<u>APPENDIX A</u>

Public Consultation Information

Neighbourhood Advisory Committee (NAC): Materials and Meeting Minutes

Summary of Comments on Preliminary Design Plans: New East-West Road NAC Meeting - October 28, 2008

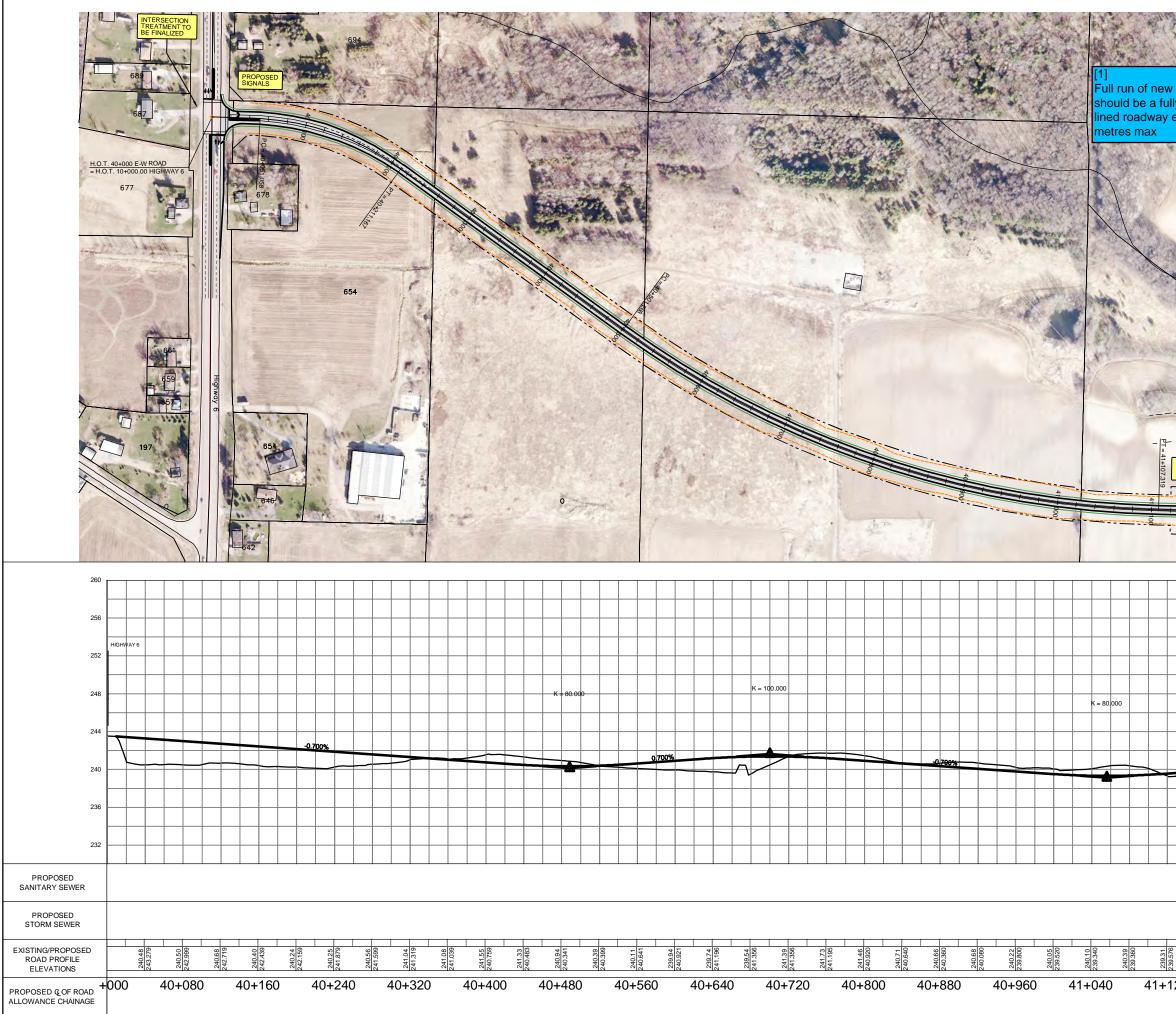
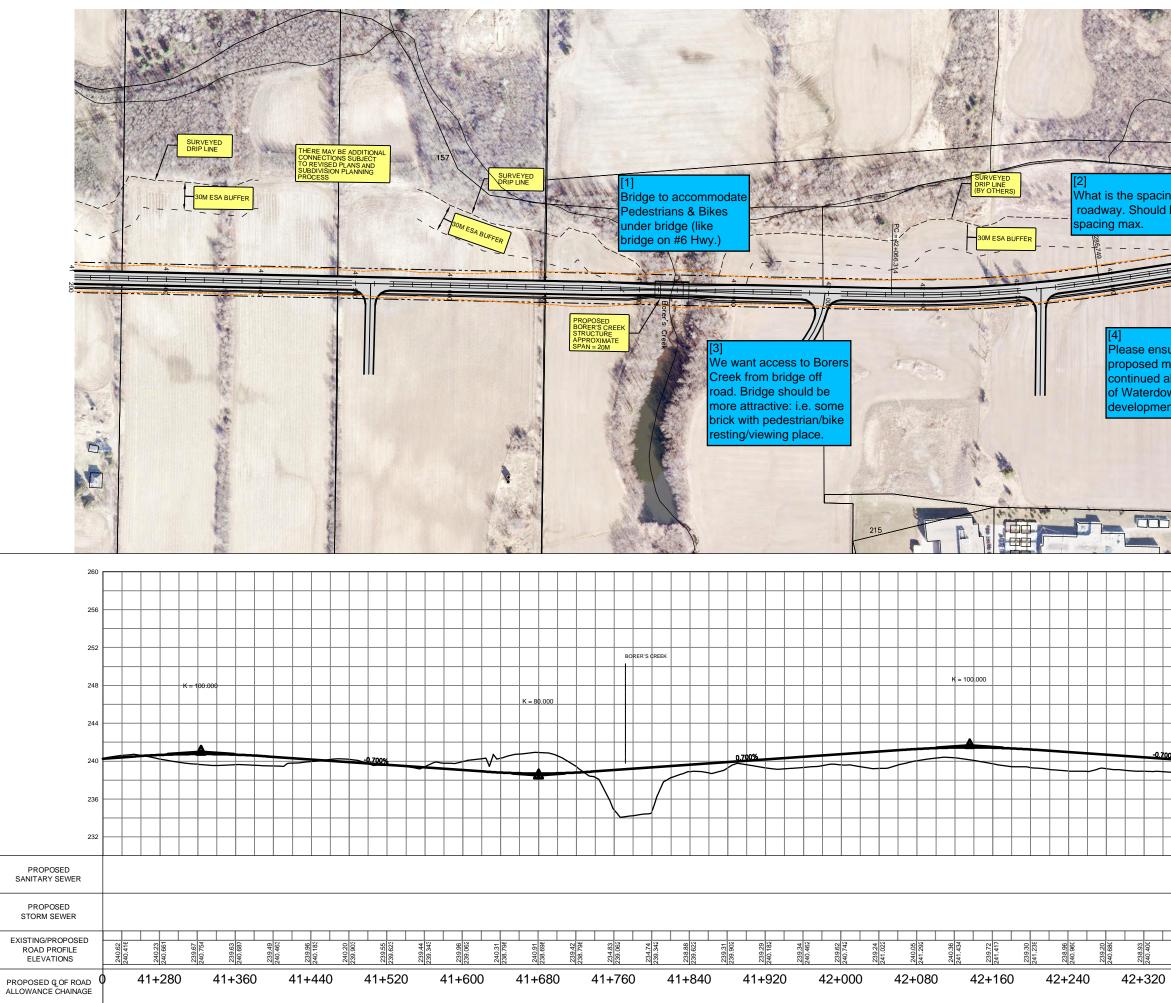
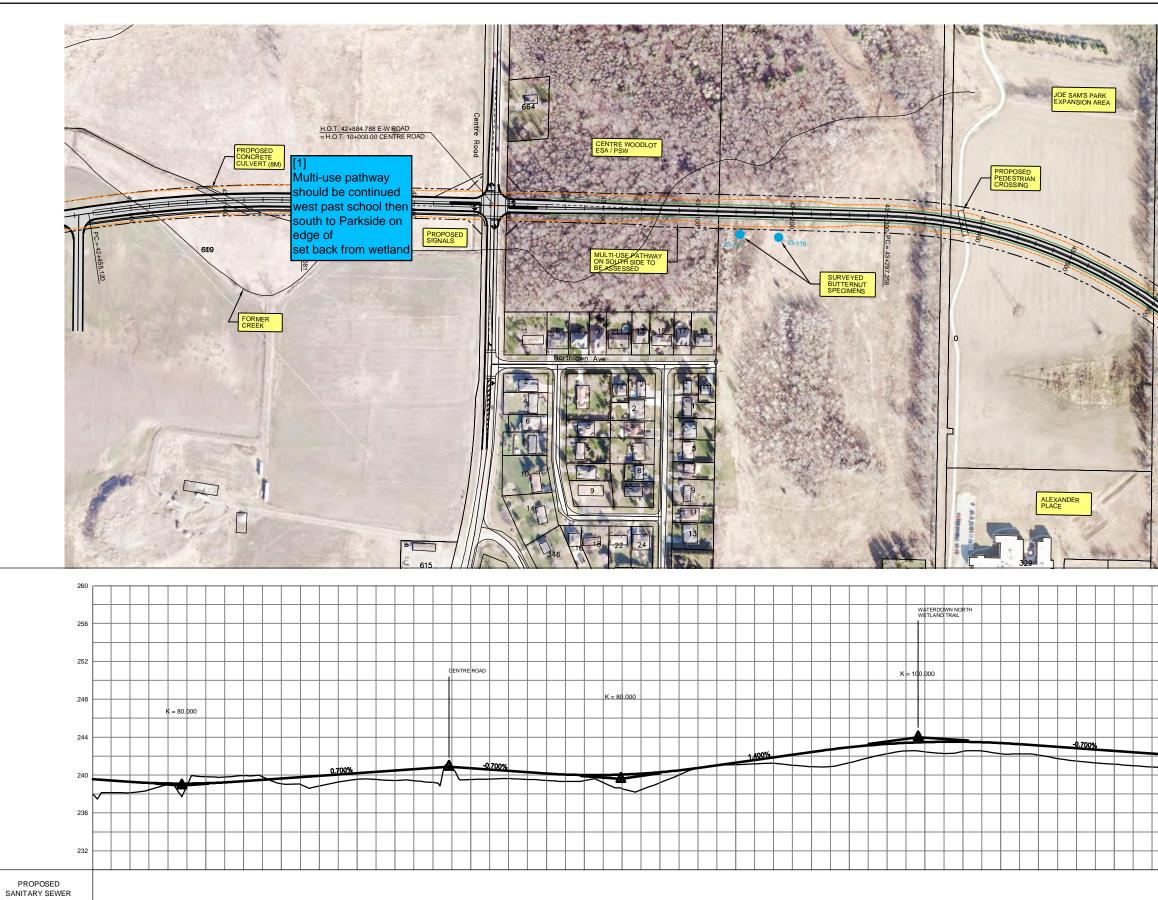
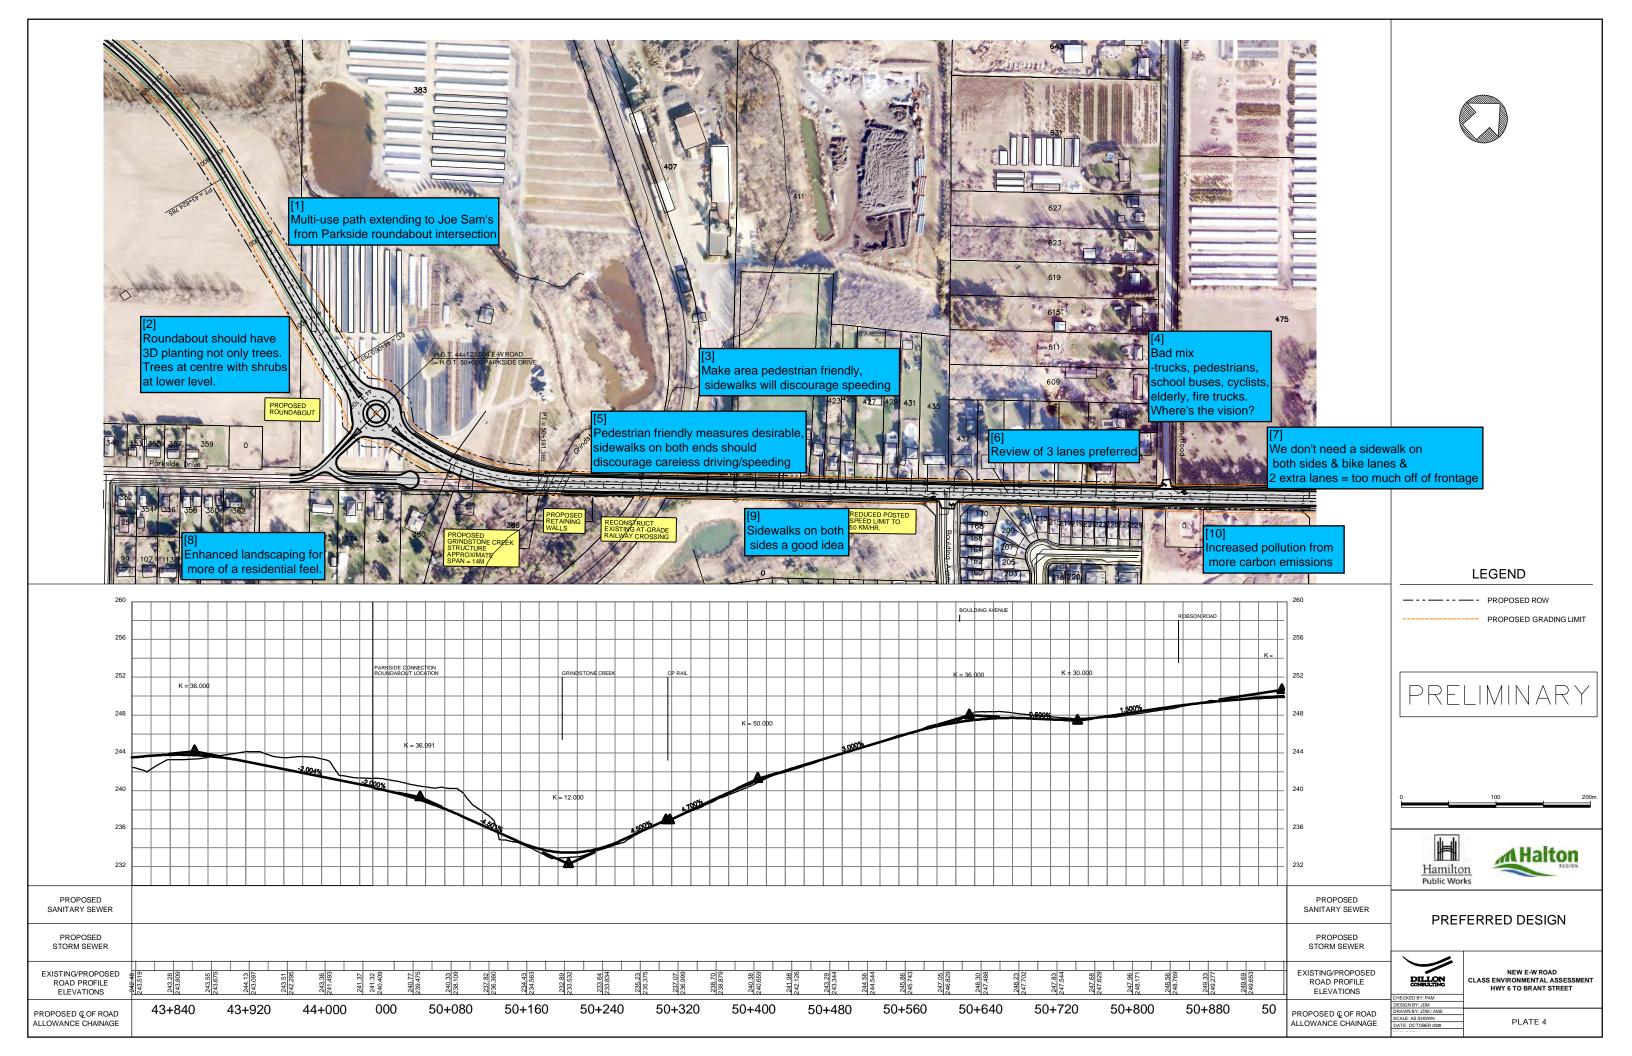
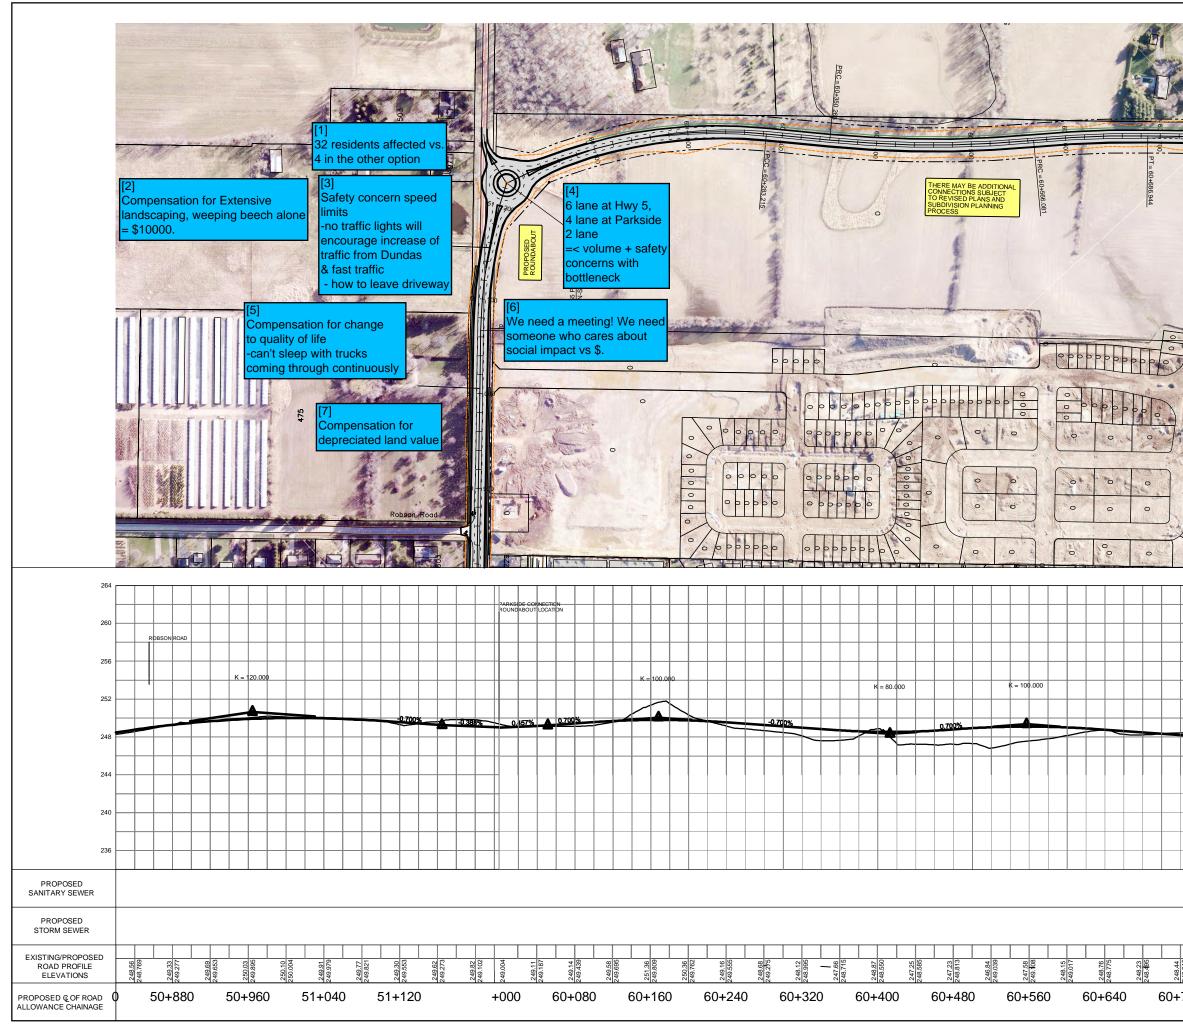
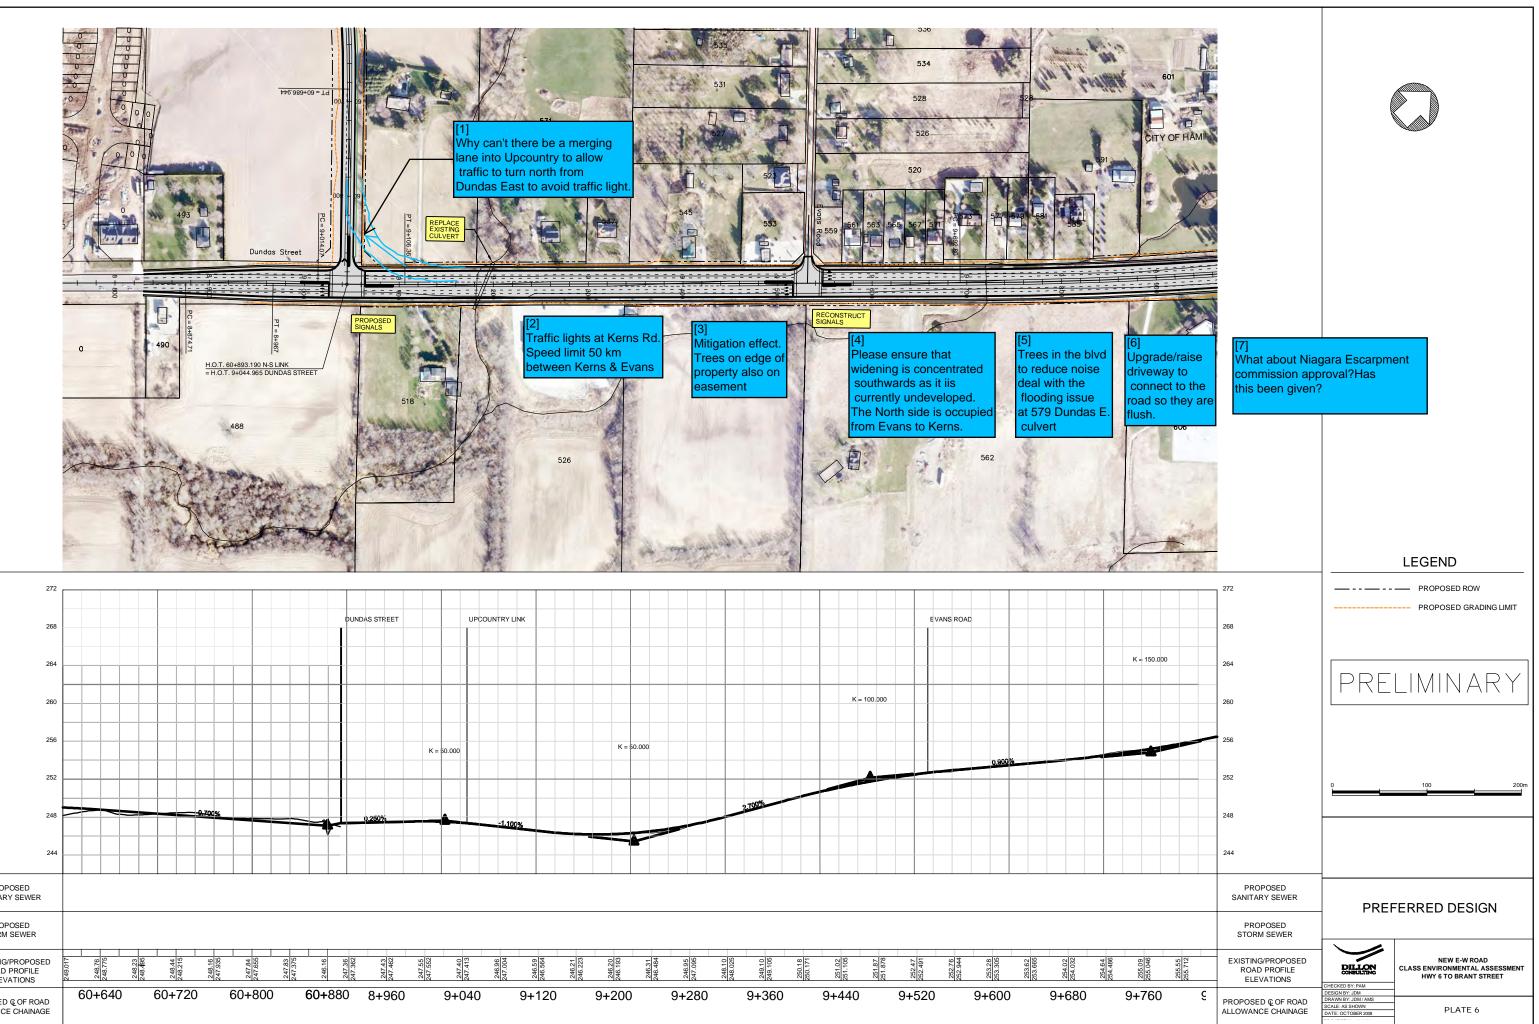
Comment	PLATE #4			
Form #5	Concerns with creation of Bottleneck on Parkside Drive due to the following factors:			
	1. Bridge at Grindstone Creek			
	2. Level Railway crossing next to Sunopta
